RE: **Coors Blvd Wecks**
730 Coors Blvd NW
Grading and Drainage Plan
Engineer's Stamp Date: 12/11/2018
Hydrology File: J11D032

Based on the submittal received on 12/21/18, the Grading and Drainage Plan cannot be approved for Site Plan for Building Permit (Administrative Amendment) or Building Permit until the following corrections are made:

[C-201]

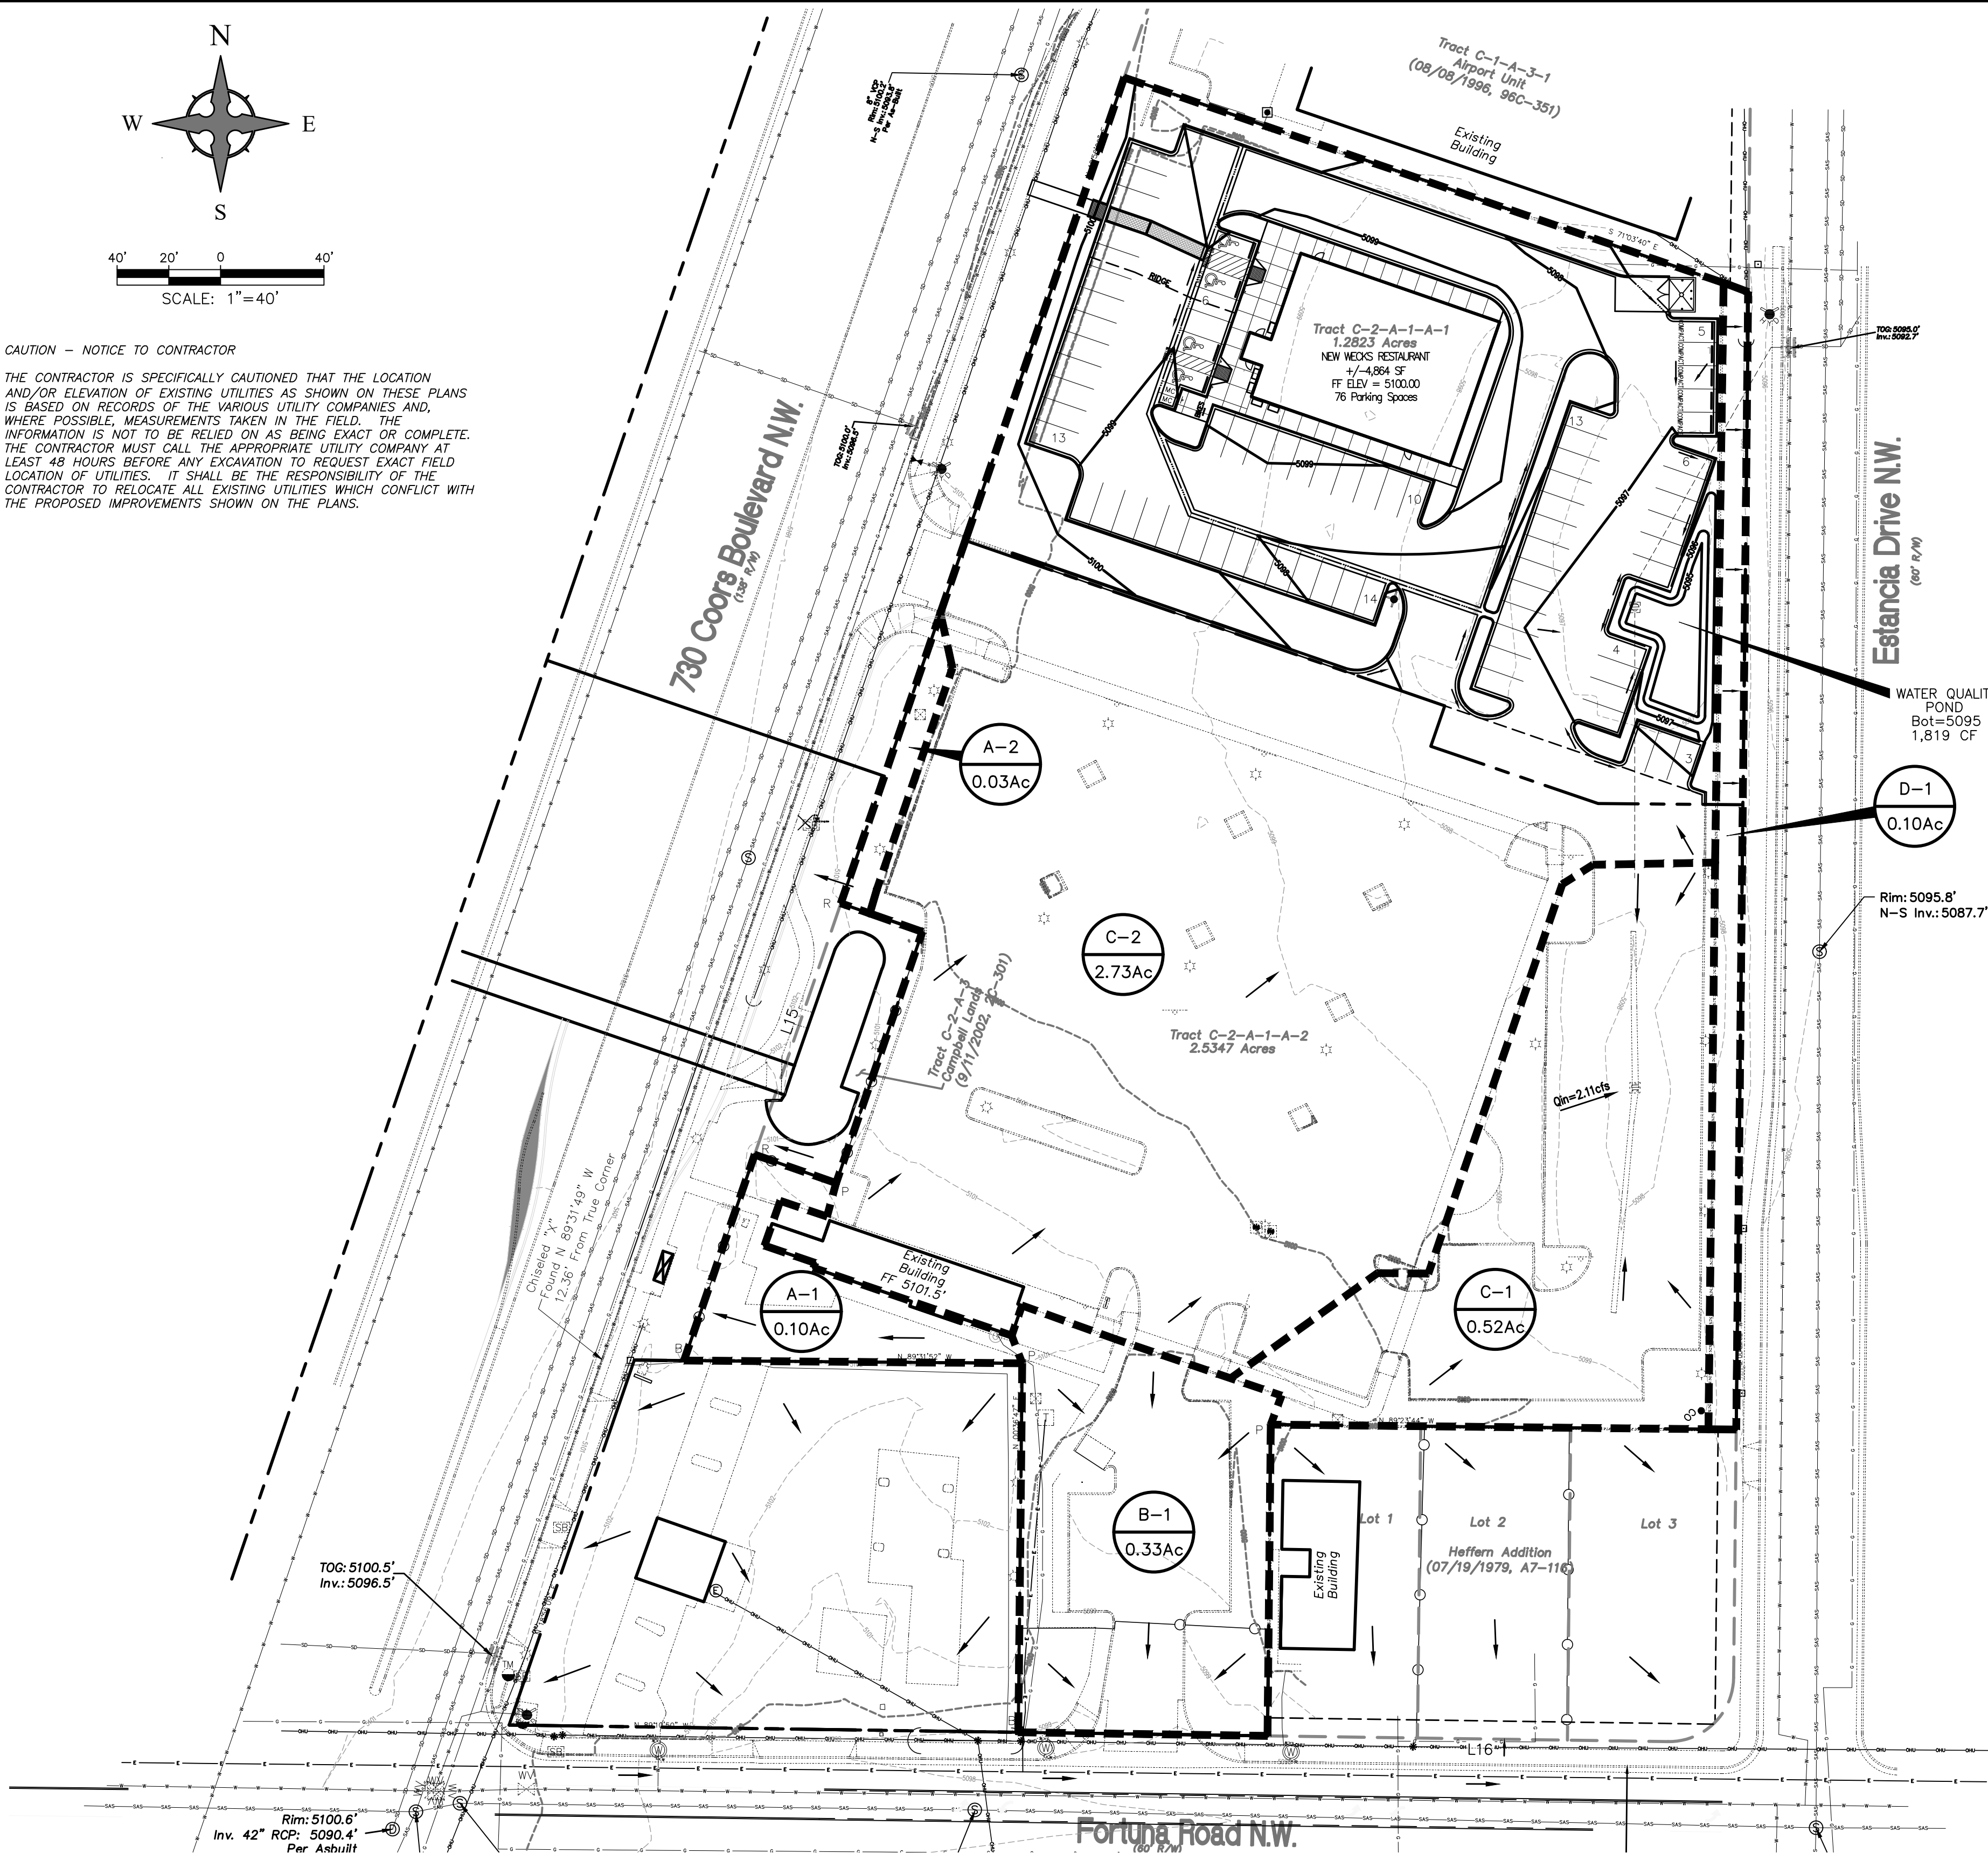
1. If only seeking Site Plan for Building Permit approval at this time, label the grading plan "Conceptual, Not For Construction" or similar. If seeking SPBP and Building Permit simultaneously, forgo the conceptual markings and address all Building Permit comments.

2. For trash enclosures serving food service developments, demonstrate control of liquids from dumpster areas per DPM Chapter 22.9.E, Table 1 by containing runoff from the dumpster area and discharging to the sanitary sewer. If this information is on the utility plan please provide it, or show on the grading plan.
3. This project requires an ESC Plan, submitted to the Stormwater Quality Engineer (Curtis Cherne PE, ccherne@cabq.gov or 924-3420).
4. Add note on the plan that "No work shall be performed in the public ROW without an approved Work Order or Excavation Permit."
5. For Information. Hydrology and Transportation files are available online through the City's GIS Viewer 2.0: <https://www.cabq.gov/gis/advanced-map-viewer>. Turn on the *HydroTrans*
